TENNESSEE VALLEY AUTHORITY  
BROWNS FERRY NUCLEAR PLANT (BFN)  
UNITS 1, 2, and 3

PROPOSED TECHNICAL SPECIFICATIONS (TS) CHANGE TS-353S1  
DESCRIPTION AND EVALUATION OF THE PROPOSED CHANGE

Figure 3.4.1-1

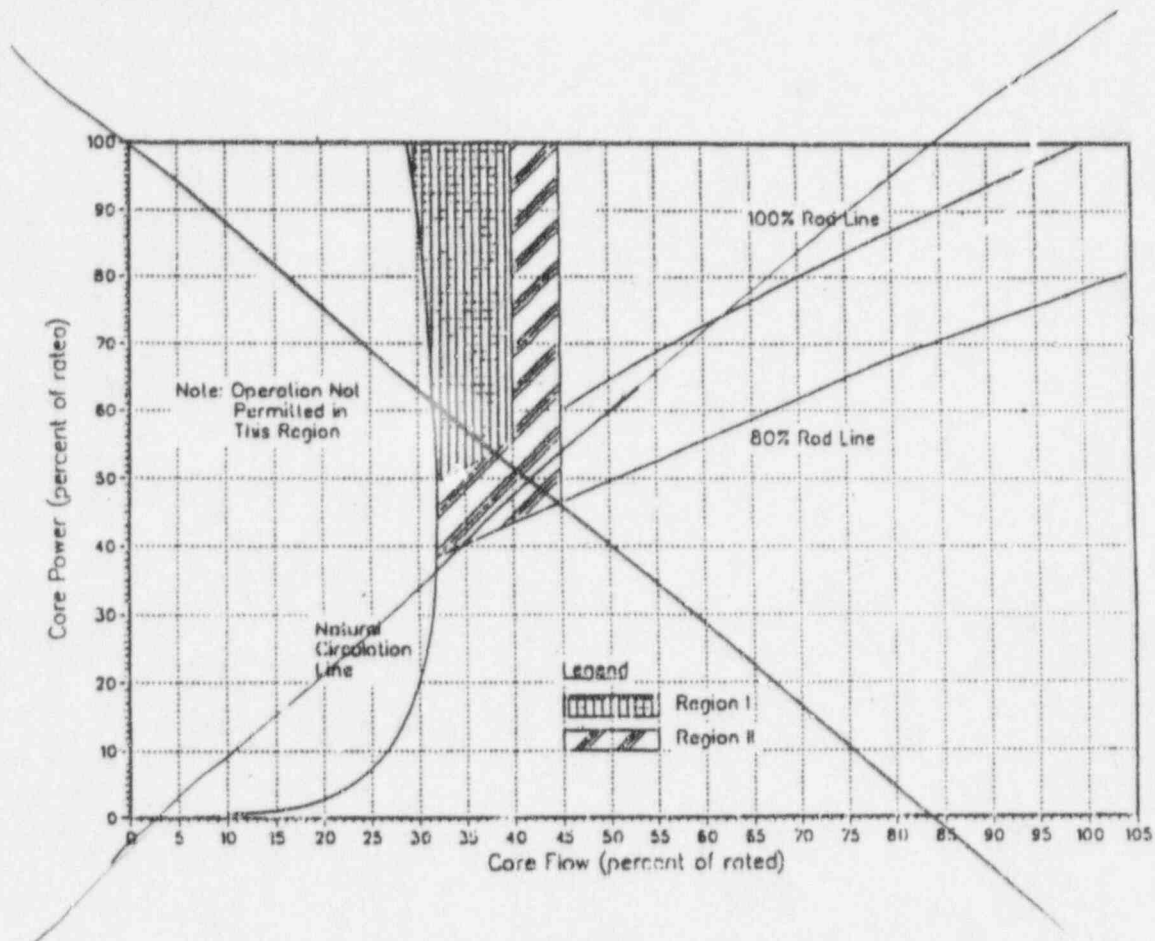
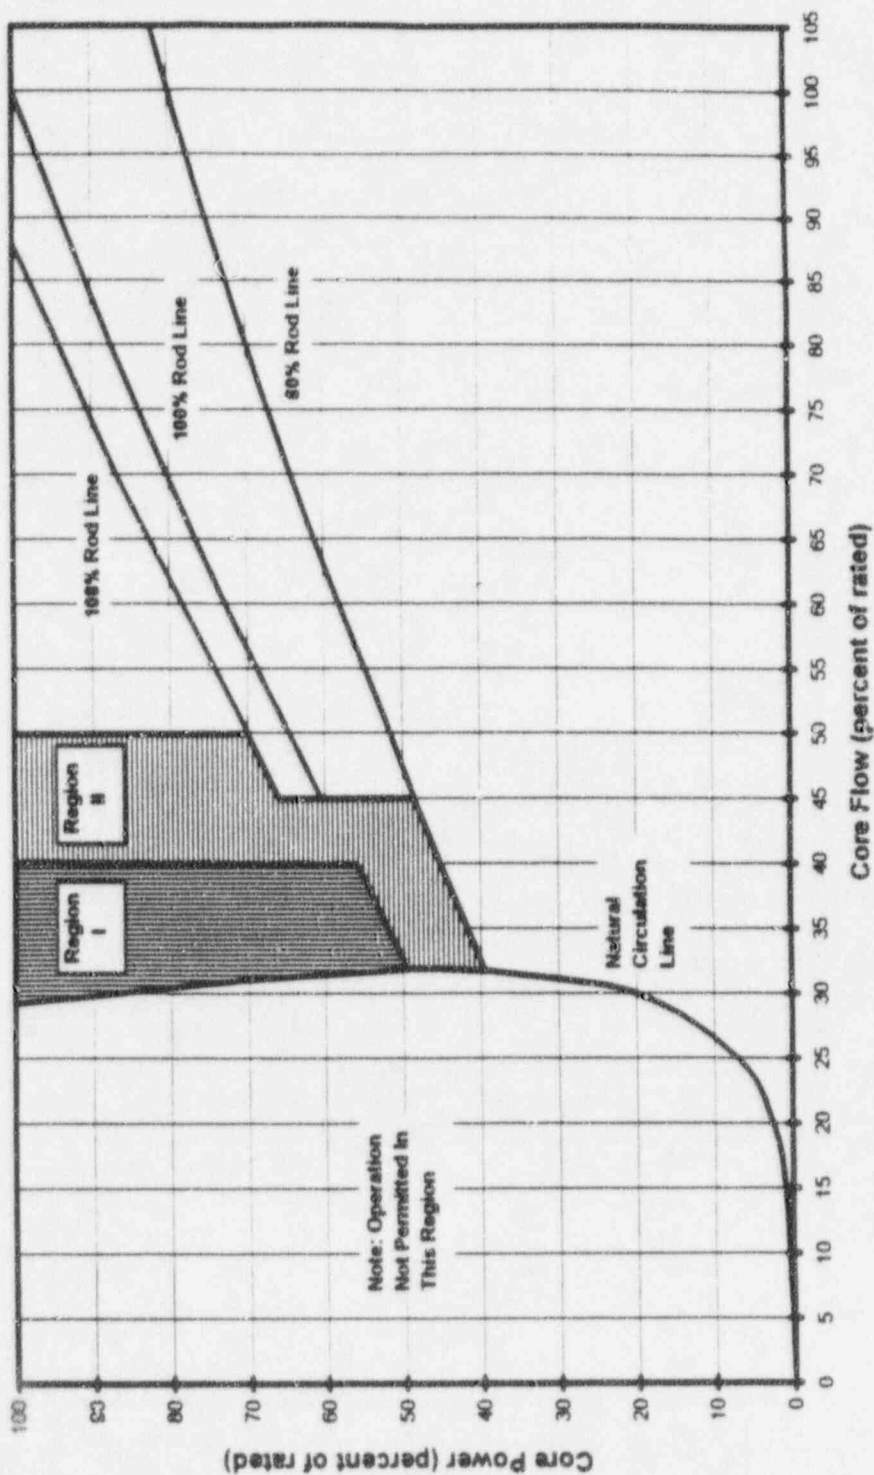
Figure 3.4.1-1 is modified to expand the Region II area to include the power/flow map area between 45% and 50% core flow, and above the 108% rod line. Also, the figure is reformatted to improve readability.

Figure 3.4.1-1, Thermal Power Versus Core Flow Stability Regions, is modified to expand Region II to include the power/flow map segment between 45% and 50% core flow, and above the 108% rod line. This change is made to preserve the BFN commitment to use the BWROG Guidelines for Stability Interim Corrective Actions. The BWROG Guidelines include this added Region II segment for plants operating under the expanded MELLL power/flow map. In SR 3.4.1.2, the 45% core flow value is changed to 50% to correspond to the change in Figure 3.4.1-1.

Figure 3.4.1-1, Thermal Power Versus Core Flow Stability Regions, is modified to expand Region II to include the power/flow map segment between 45% and 50% core flow, and above the 108% rod line. This change is made to maintain compatibility with the improved BWROG Guidelines for Stability Interim Corrective Actions for plants operating under a MELLL expanded power/flow map. Prior to implementation of MELLL, the existing APRM rod blocks and load line limitations physically restricted reactor entry in this area. With the MELLL expanded power/flow map and increased rod block lines, it becomes possible to operate in this area. The BWROG Guidelines, however, classify this area as a Region II restricted area, and to stay consistent with BFN's commitments to implement the BWROG Stability Guidelines, the TS Figure is modified to include this power/flow map region as Region II area. SR 3.4.1.2 is also modified to increase the SR domain from 45% to 50%

Replace with  
improved Figure

Replacement  
Figure

Figure 3.4.1-1

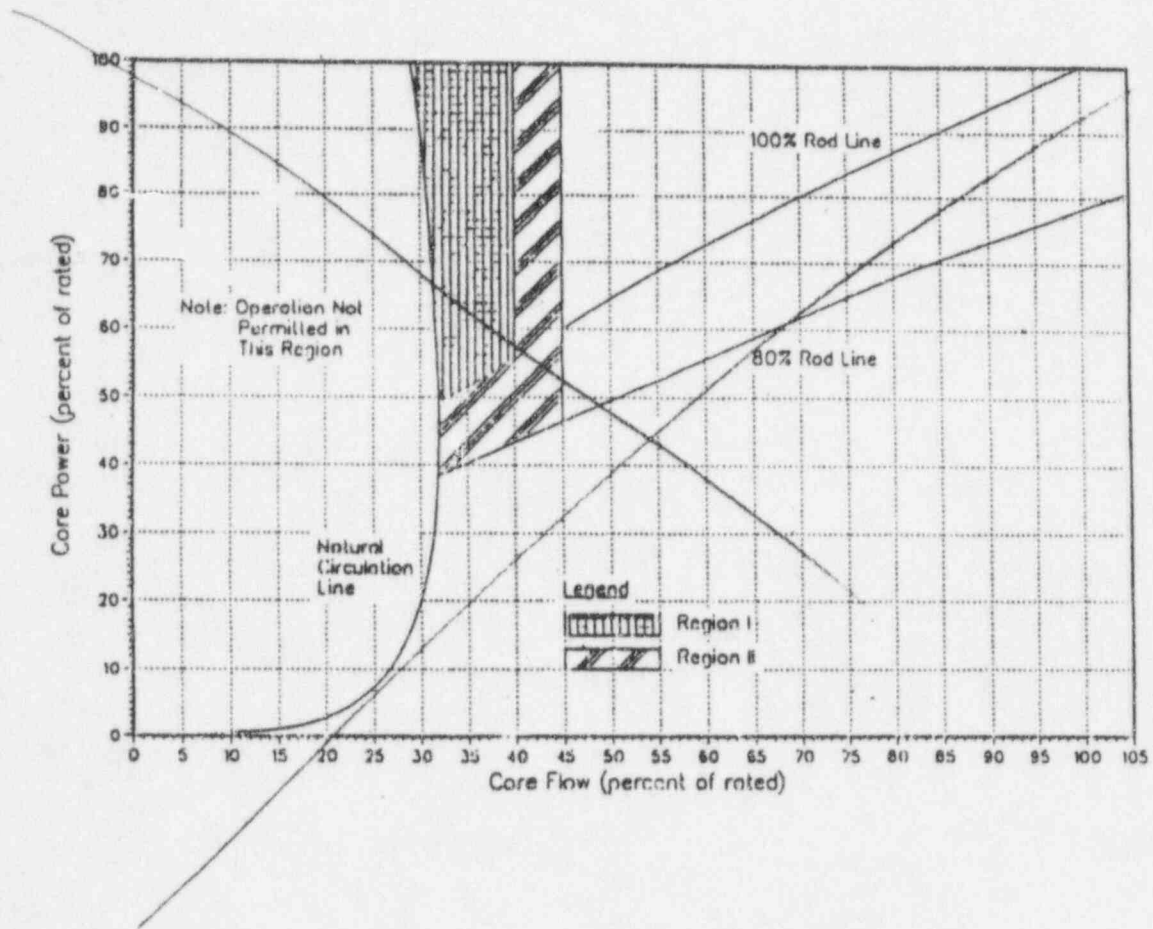
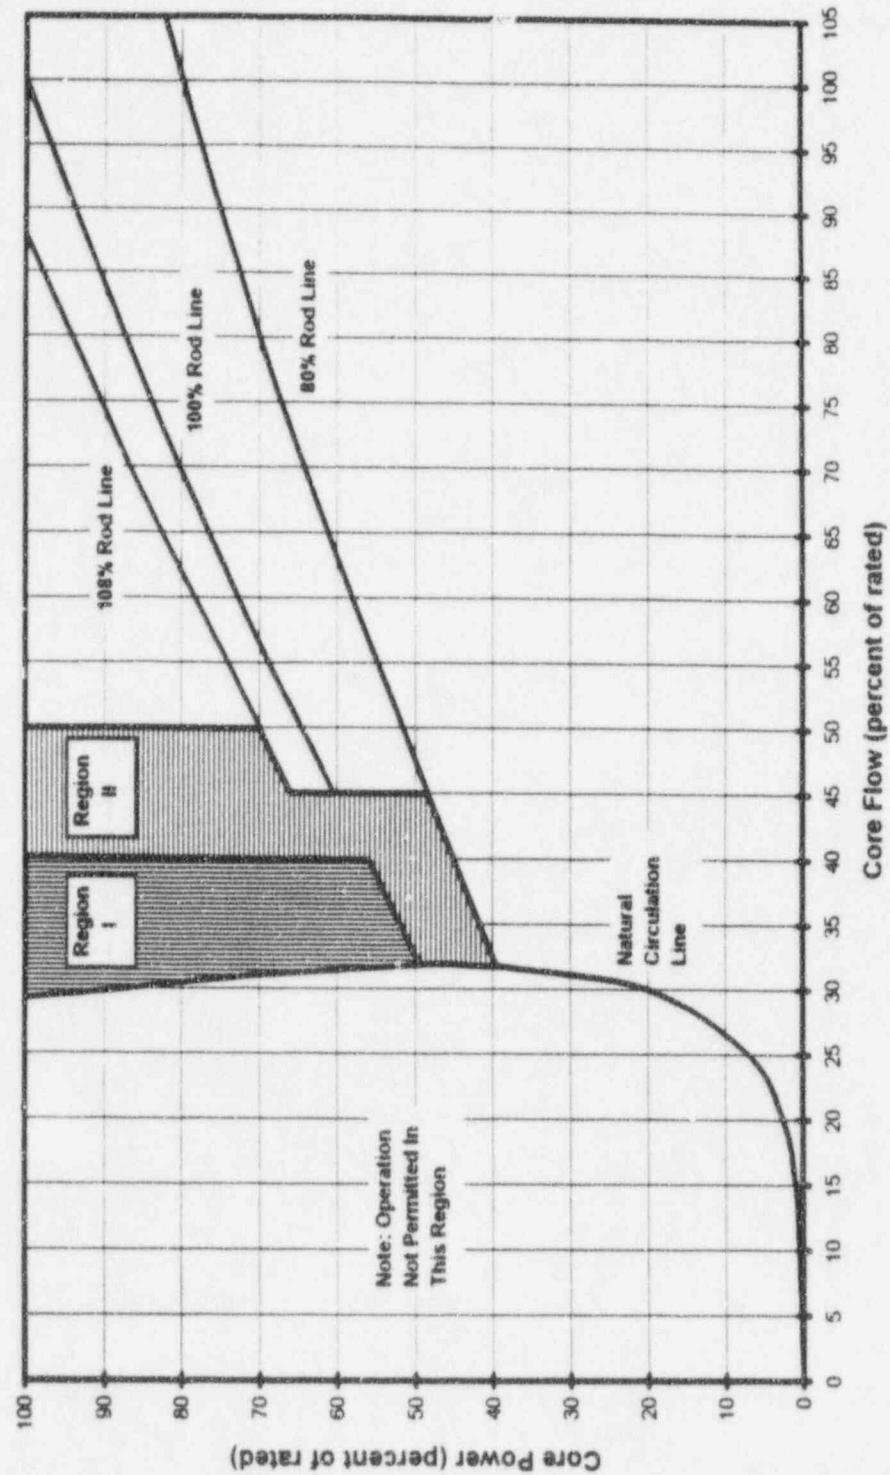
Replaces with  
Improved Figure

Replacement  
Figure

Figure 3.4.1-1

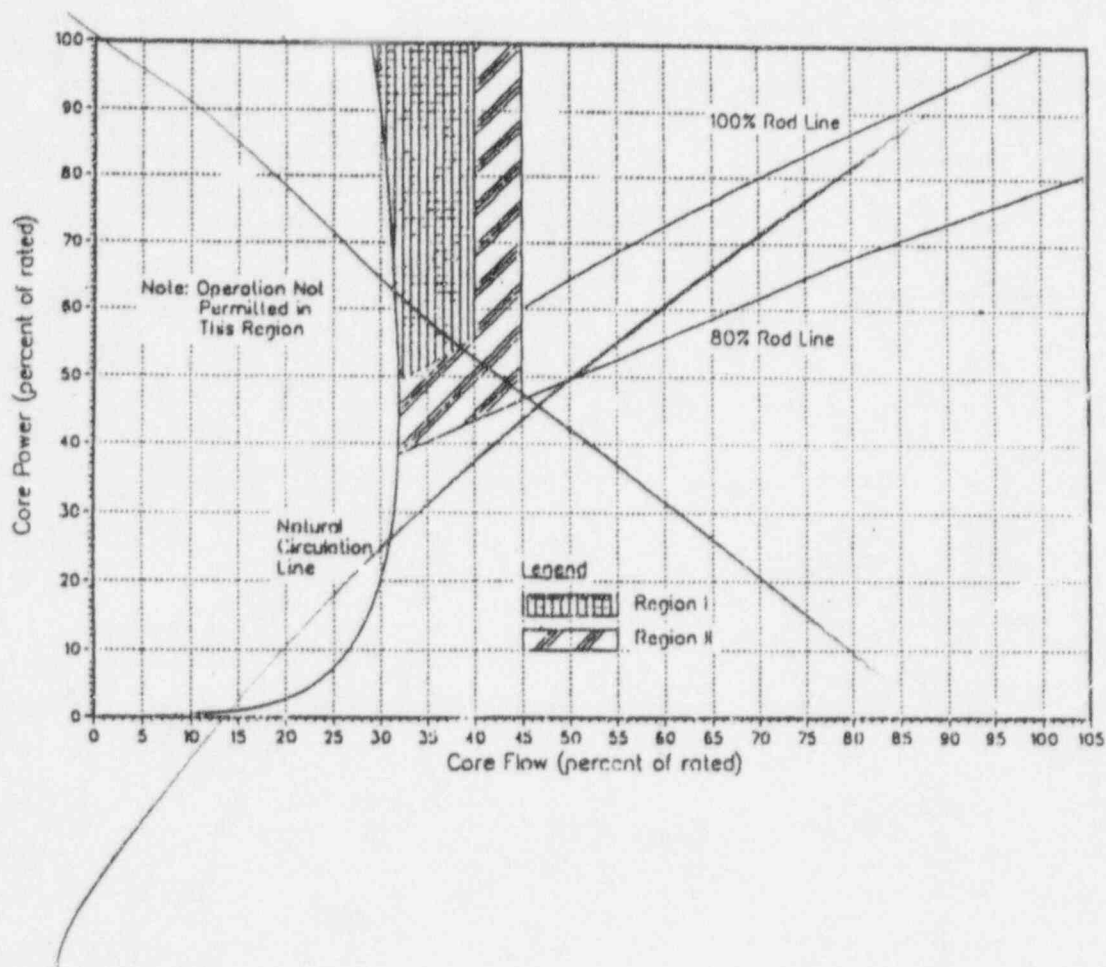
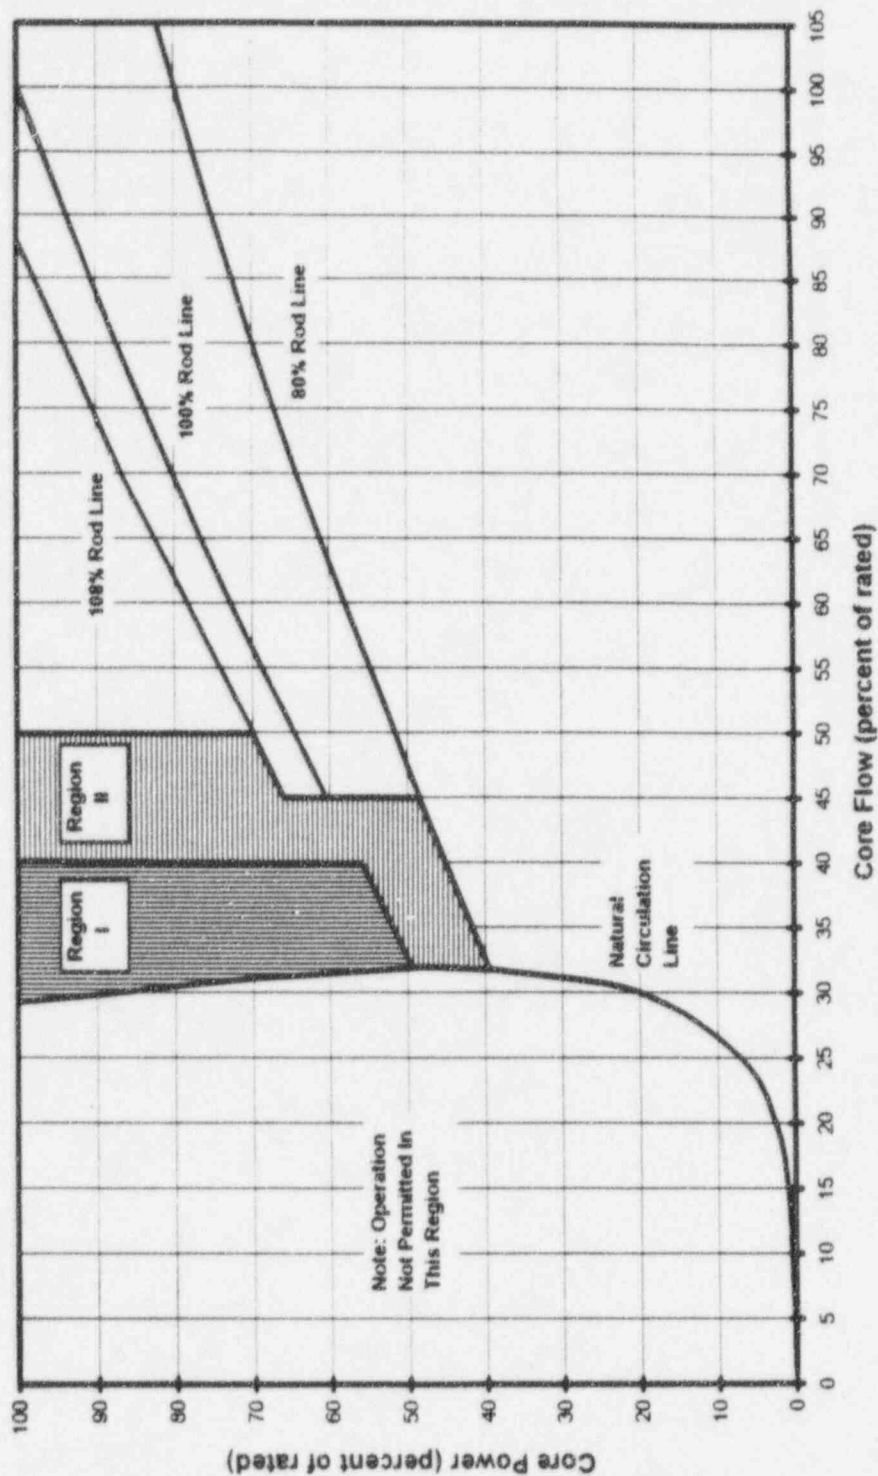
Replace with  
Improved Figure

Improved  
Figure
